SIGN #:
1 OF 4

SIGN PLAN | SIZING

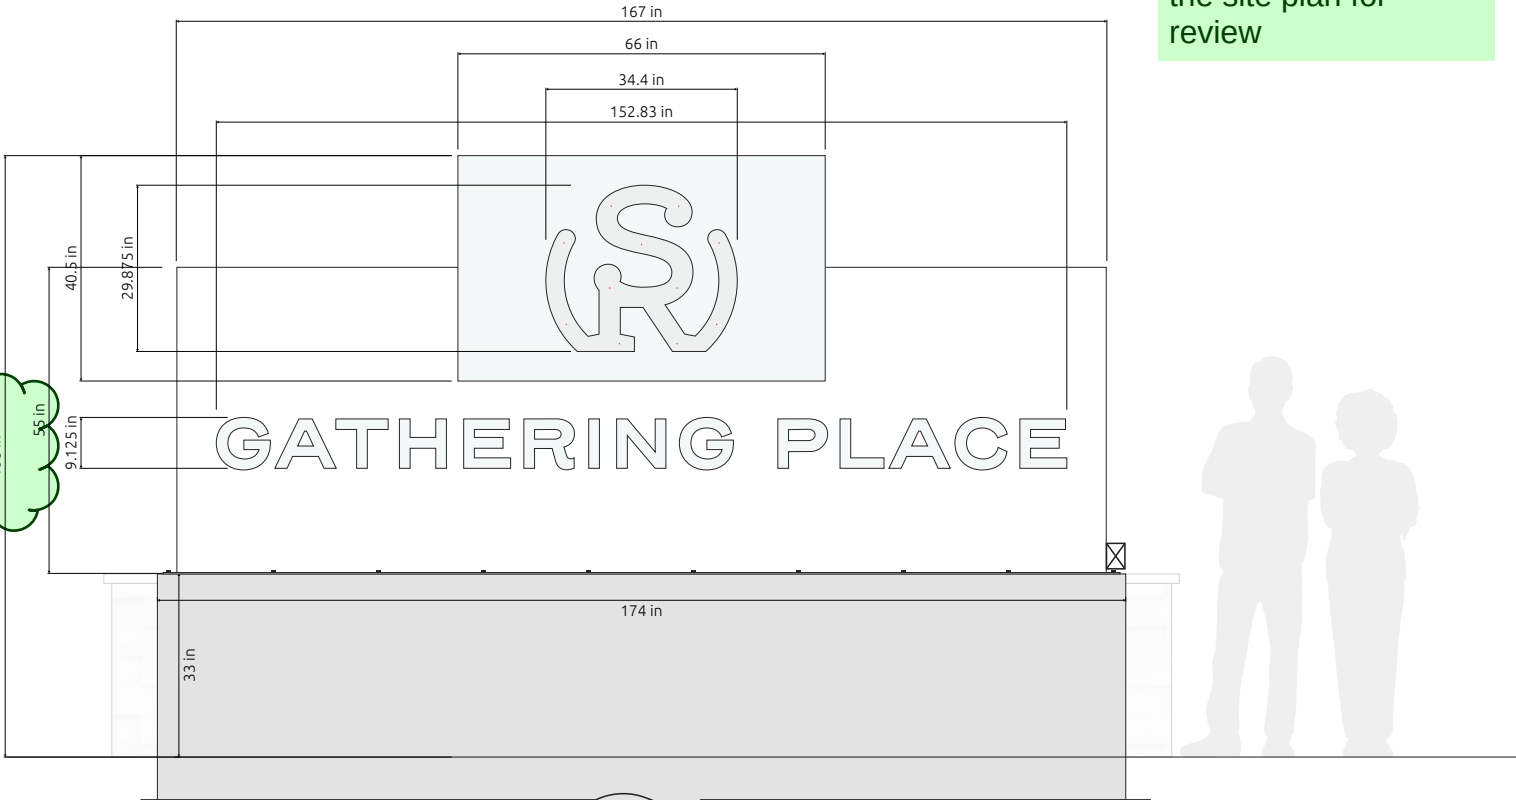
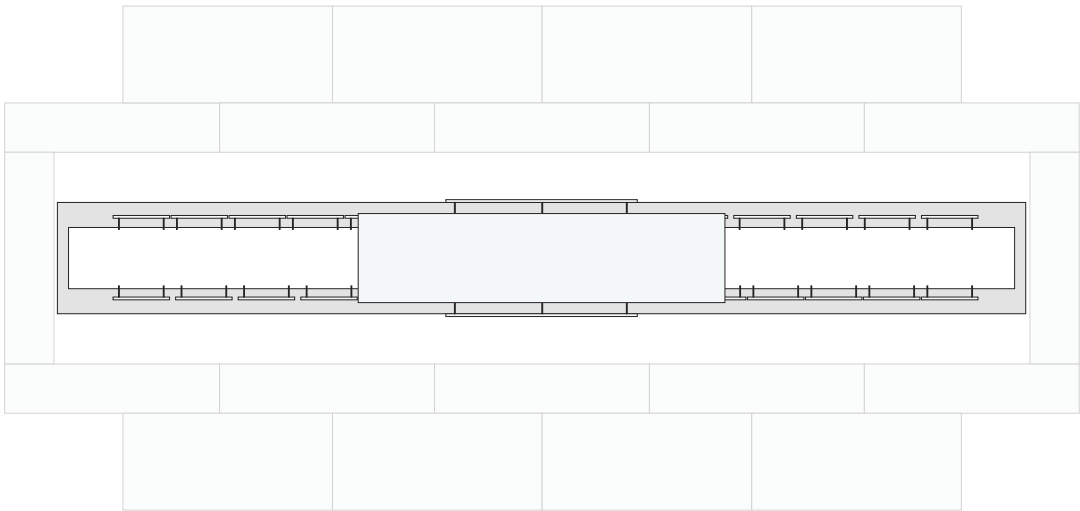
There only appears to be one sign on the site plan. Please correct this or show the other 3 signs on the site plan for review

There only appears to be one sign on the site plan. Please correct this or show the other 3 signs on the site plan for review

SITE PLAN

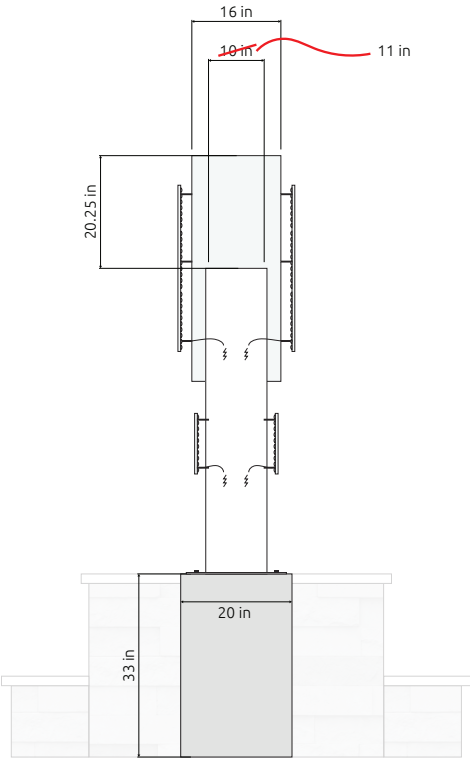
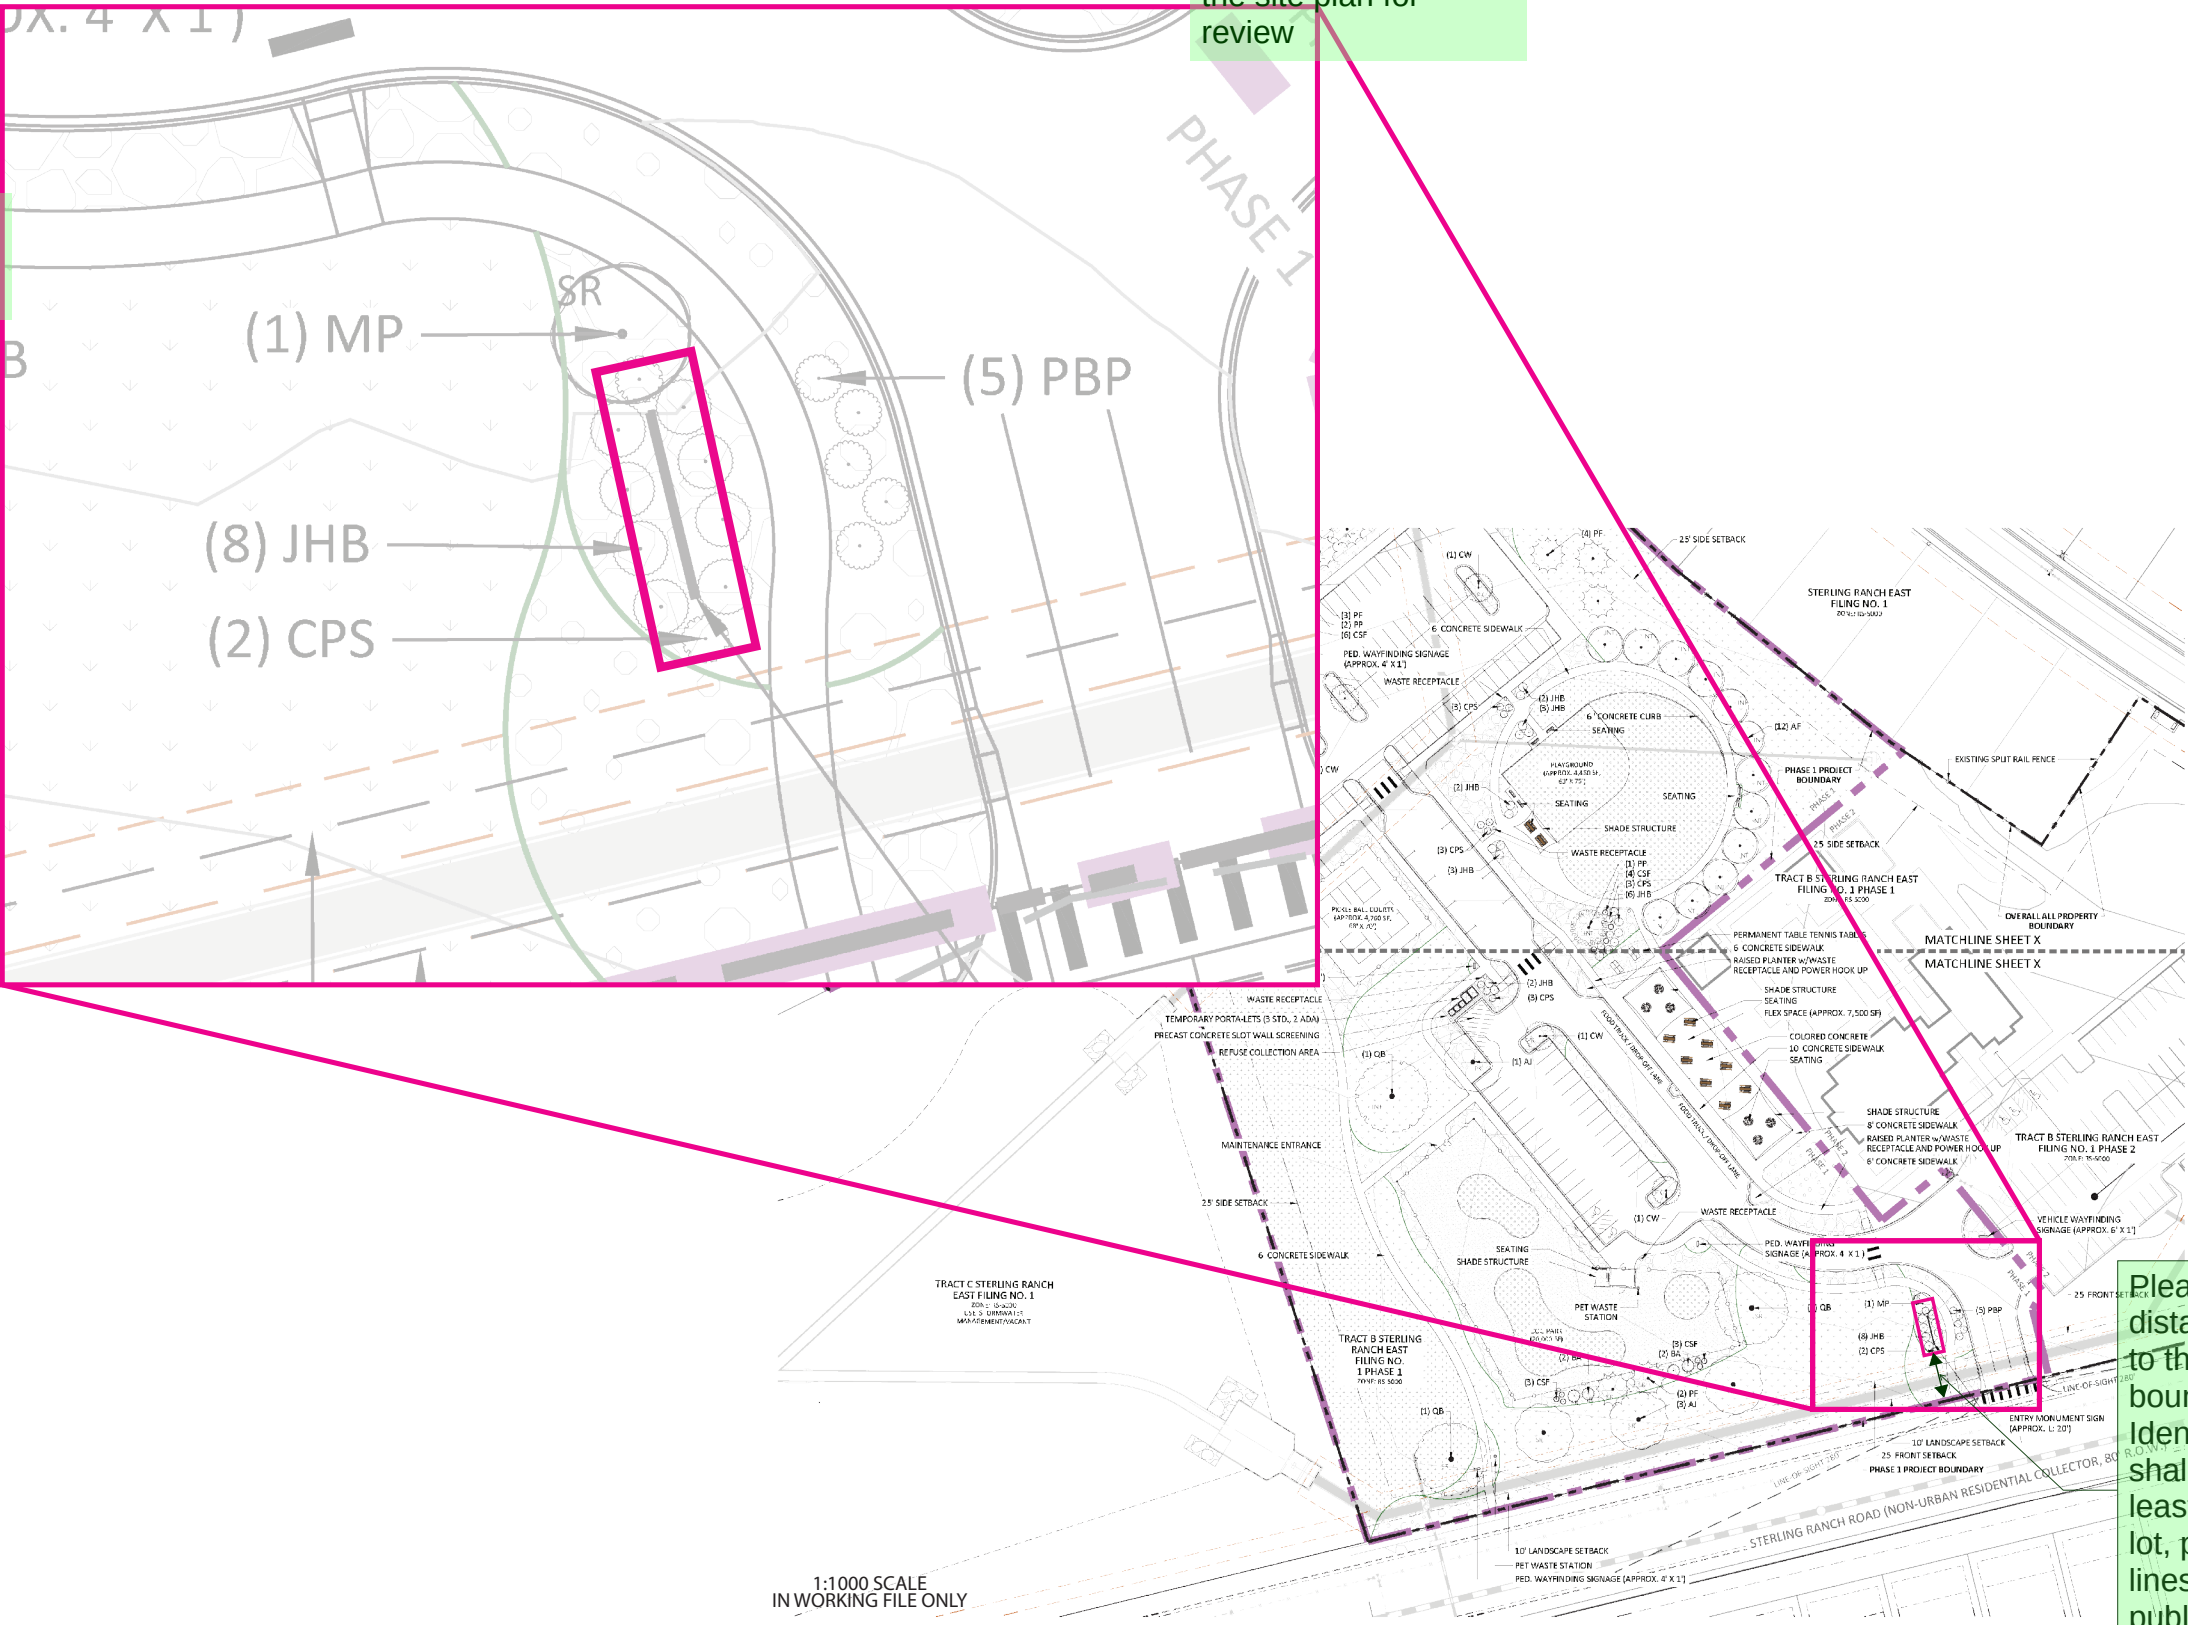
this is not the correct address for this sign application. Please use 8440 Sterling Ranch Rd

There only appears to be one sign on the site plan. Please correct this or show the other 3 signs on the site plan for review

Please indicate the distance from the sign to the property boundary. Identification signs shall be located at least 25 feet from all lot, parcel, or tract lines adjacent to public and private rights-of-way or easements.

SIGN PLAN | CALL-OUTS

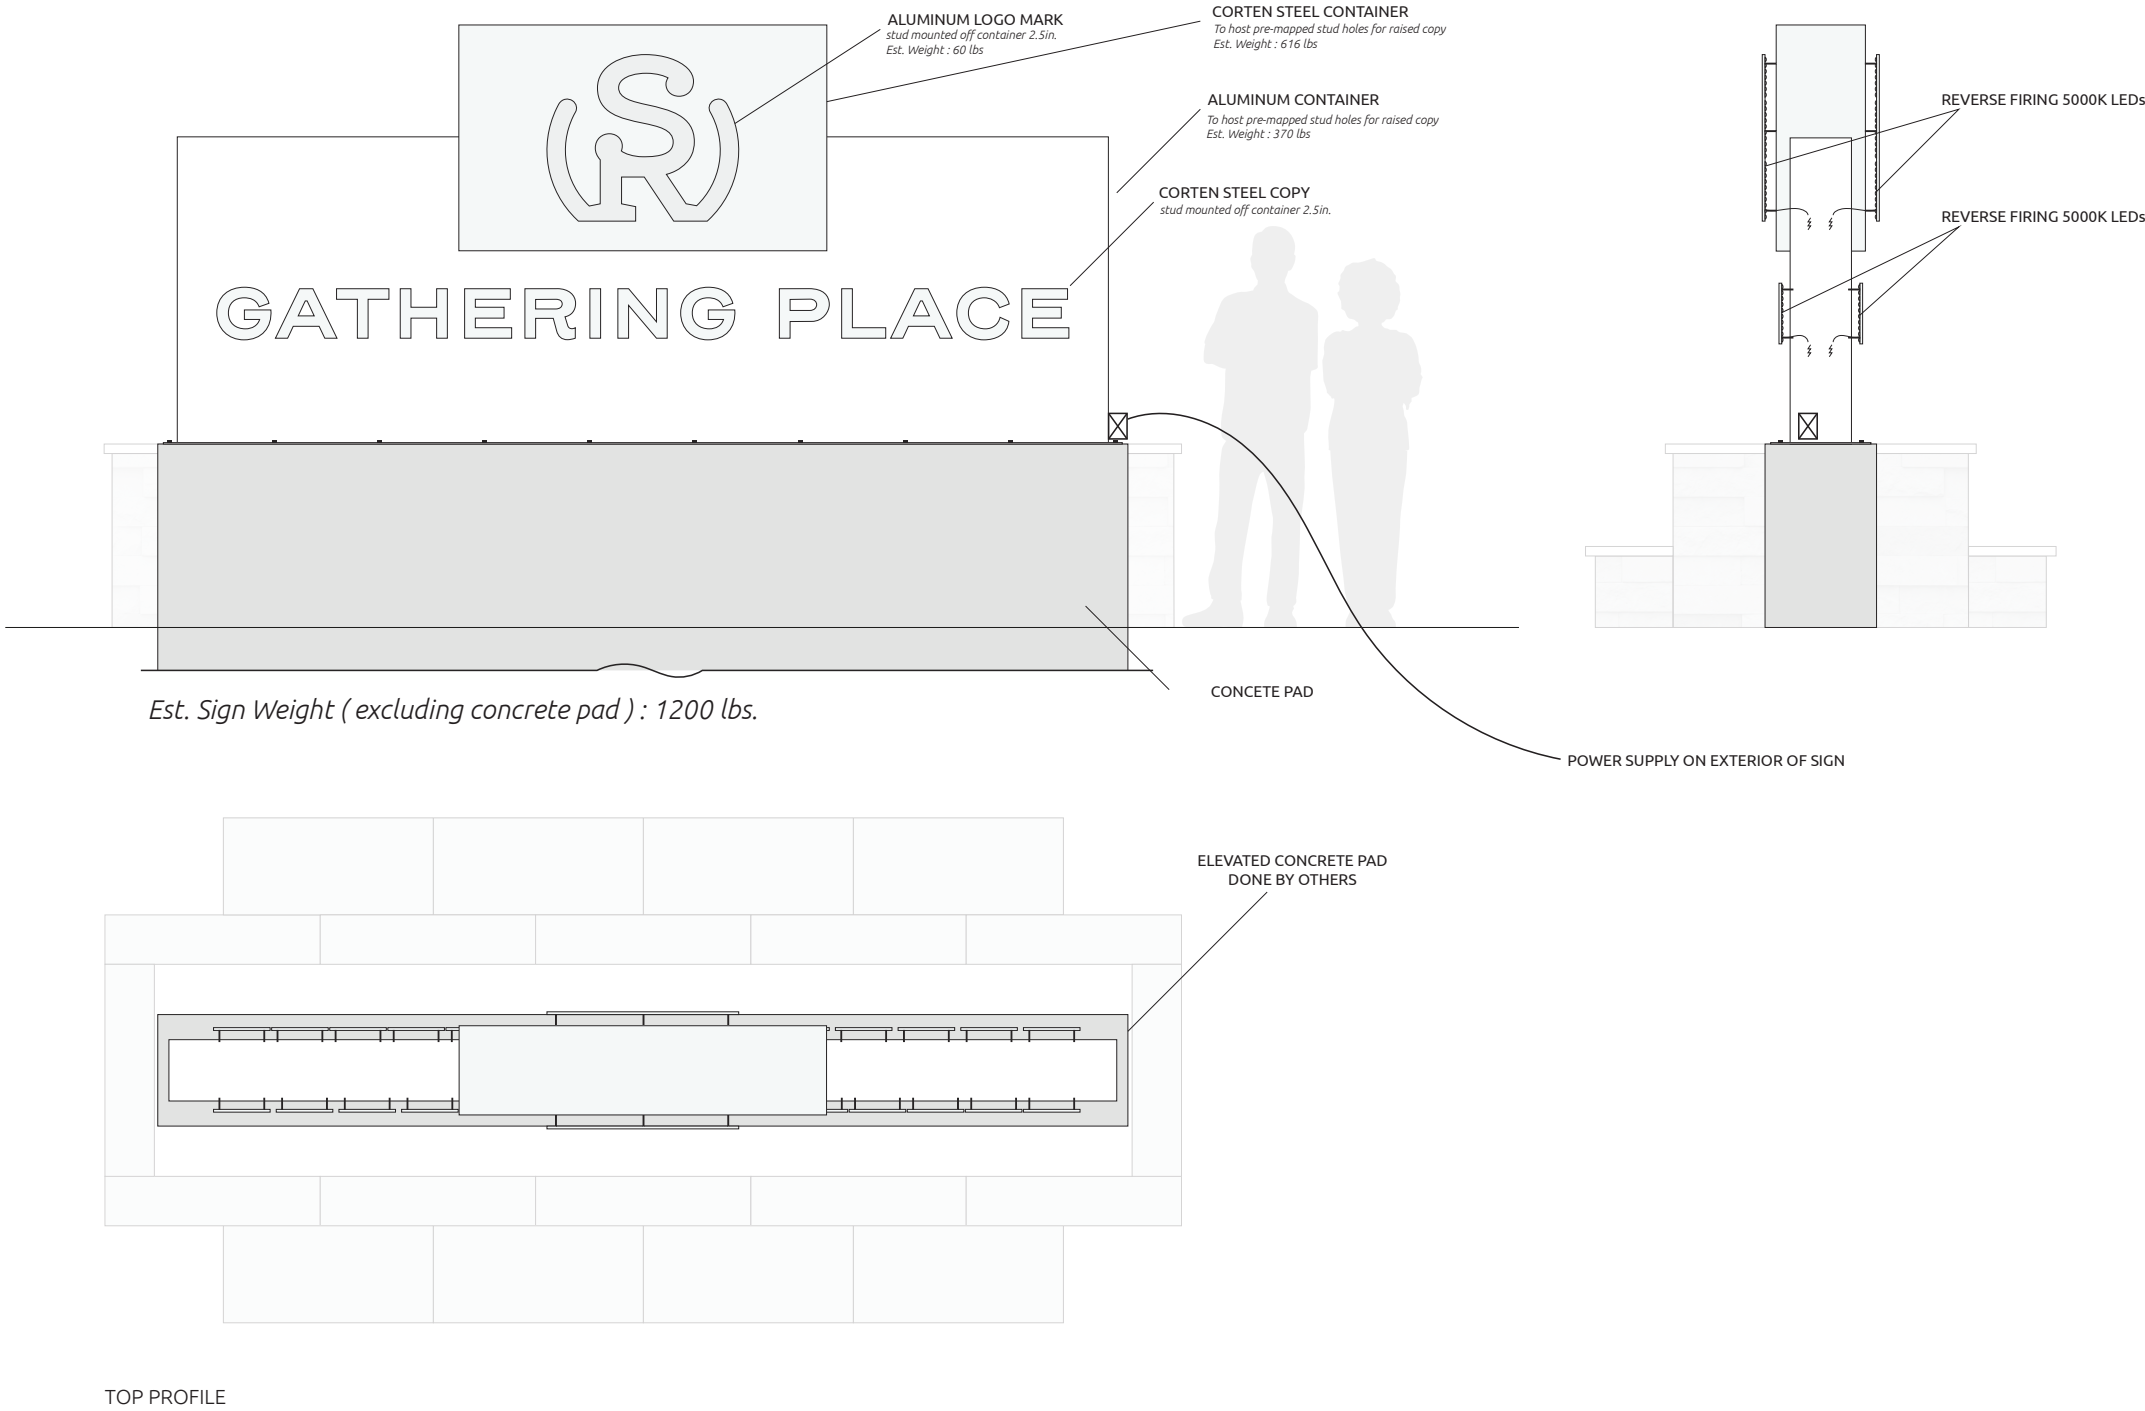
There only appears to be one sign on the site plan. Please correct this or show the other 3 signs on the site plan for review

SIGN PLAN | PLANTER METHOD

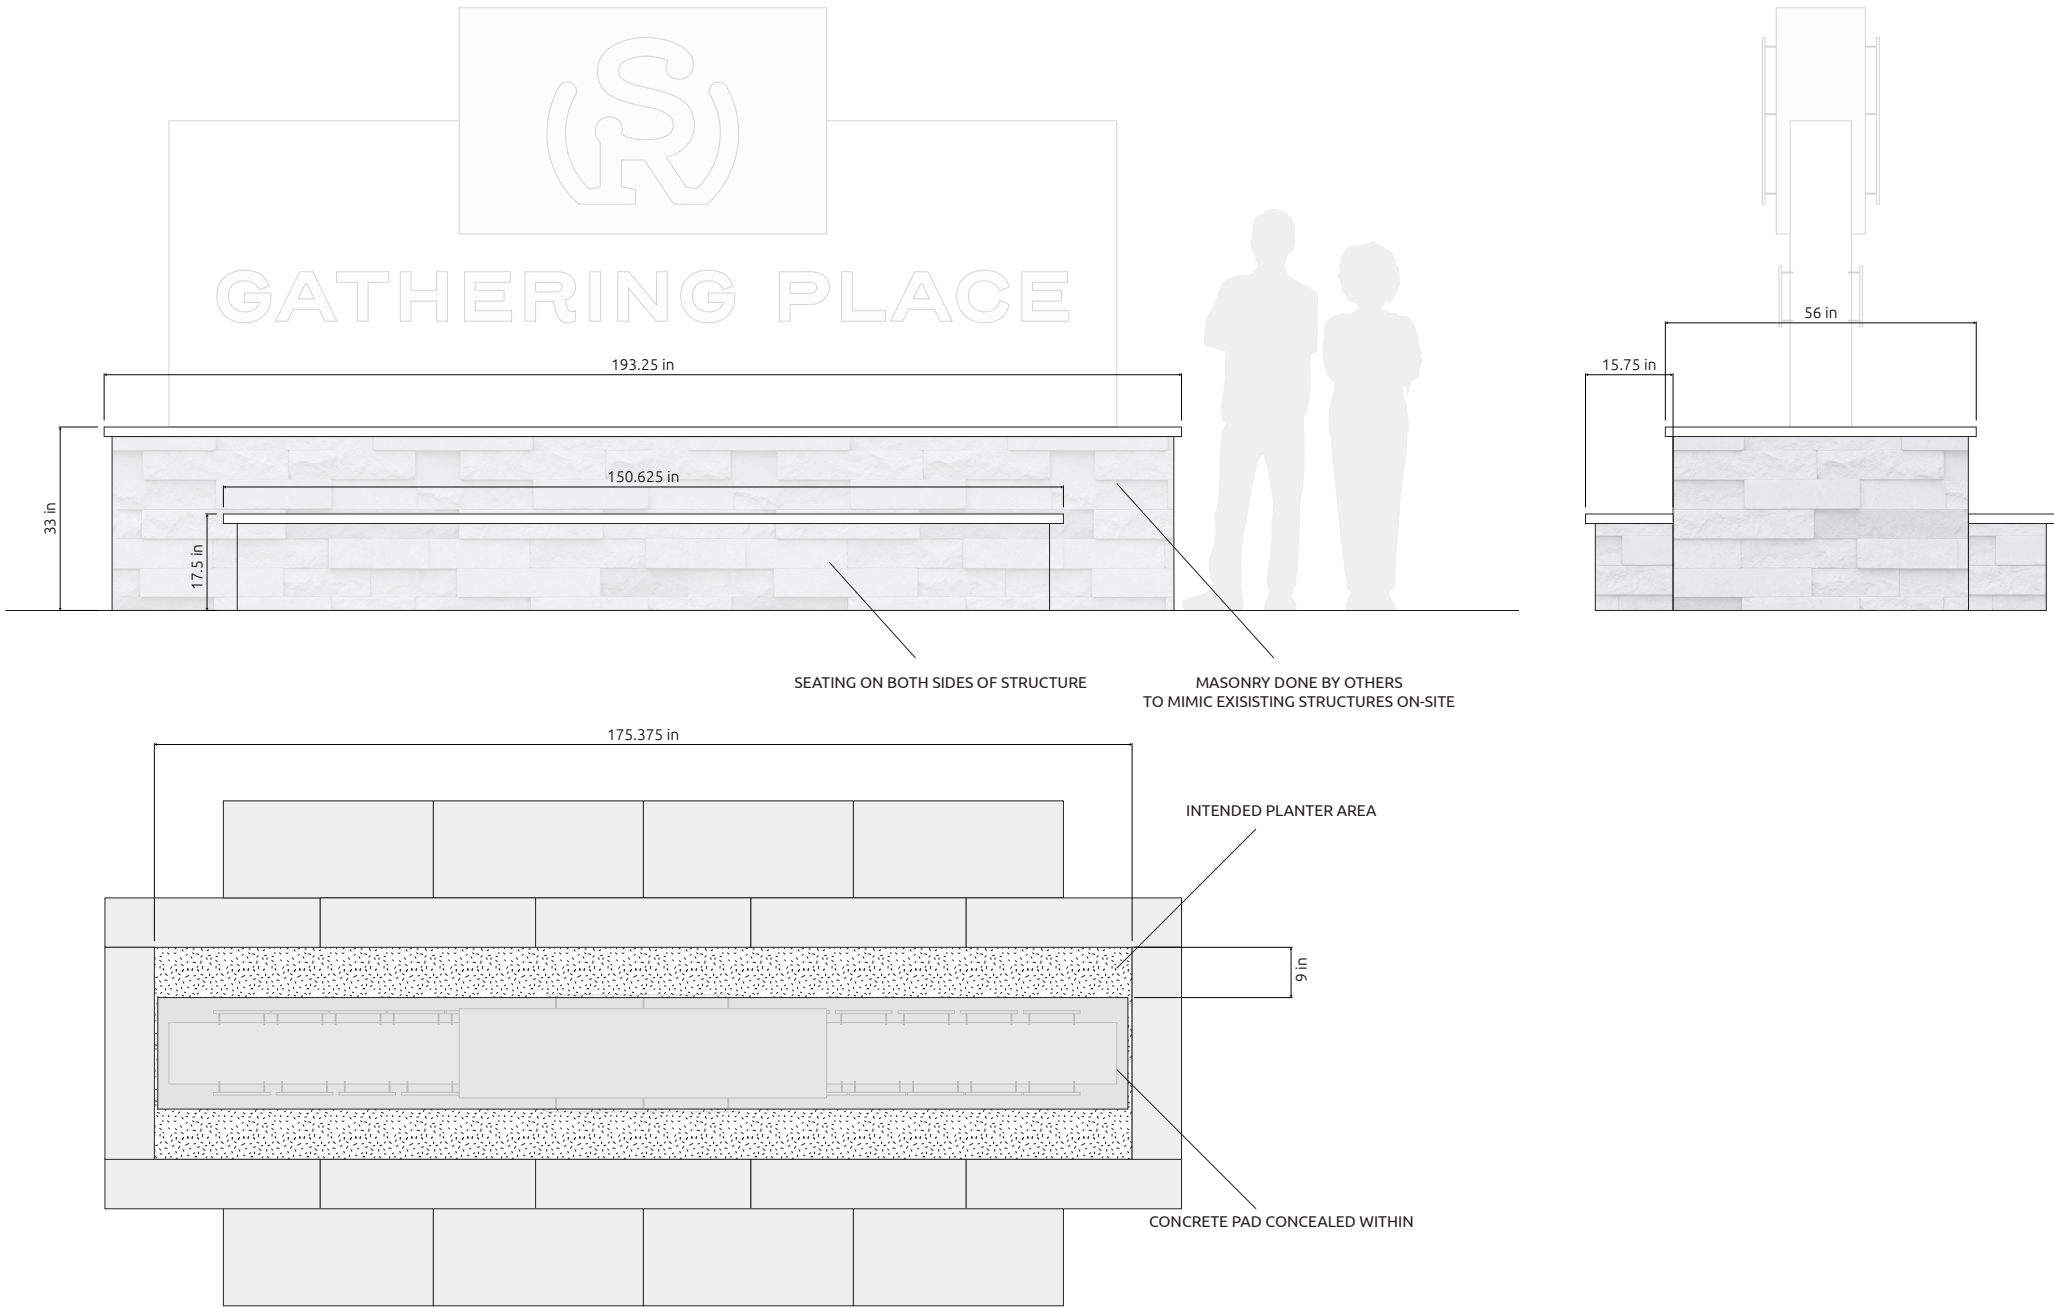
There only appears to be one sign on the site plan. Please correct this or show the other 3 signs on the site plan for review
